## ADDENDUM NO. 1

## May 23, 2022

PROJECT: PROPOSED COMMUTER PARKING STAIRWAY IMPROVEMENTS VILLAGE OF HASTINGS-ON-HUDSON WESTCHESTER COUNTY, NEW YORK

1" = 20' 4/27/22 DRAWING NO. SHEET NO. **C-1** 1 of 3

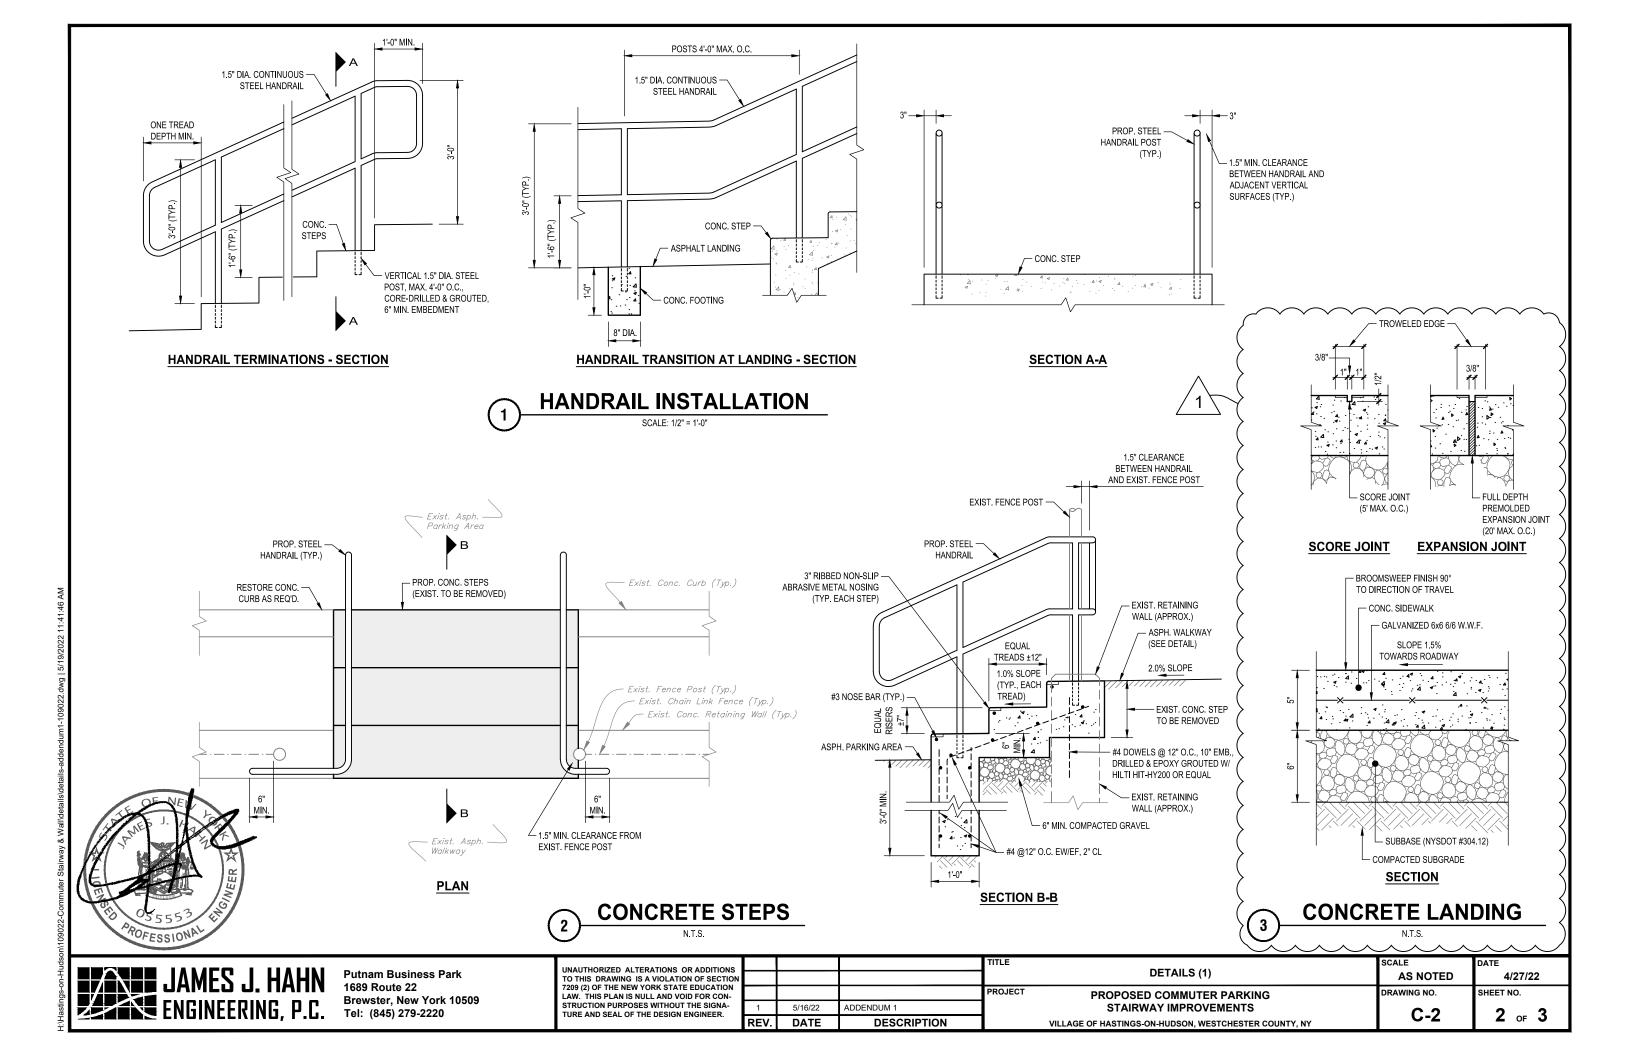
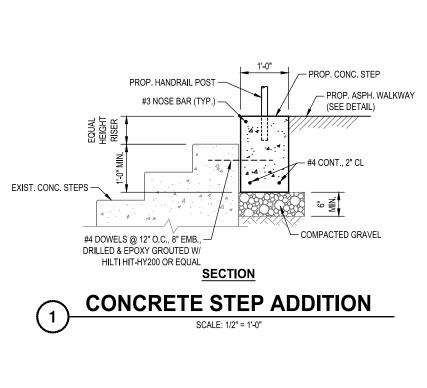
- 1) Bid Proposal, **REMOVE** Page 5 of 6 and **INSERT** Page 5 of 6 (Add #1) and Page 5A of 6 (Add #1), attached.
- 2) Drawings C-1, C-2 and C-3 have been revised dated 5/16/2022, attached.
- 3) Concrete step repair shall include a concrete bonding agent, Weld-Crete or approved equal.
- 4) Pertinent notes from the Pre Bid Project meeting held on May 17, 2022 are below.
  - Additional details are noted on Addendum No.1 that include a concrete landing alternate, and existing concrete step repair.
  - The lower parking lot (a/k/a Con-Ed Lot) is owned by the Village and may be used for staging. Exact location and area to be coordinated with the Village.
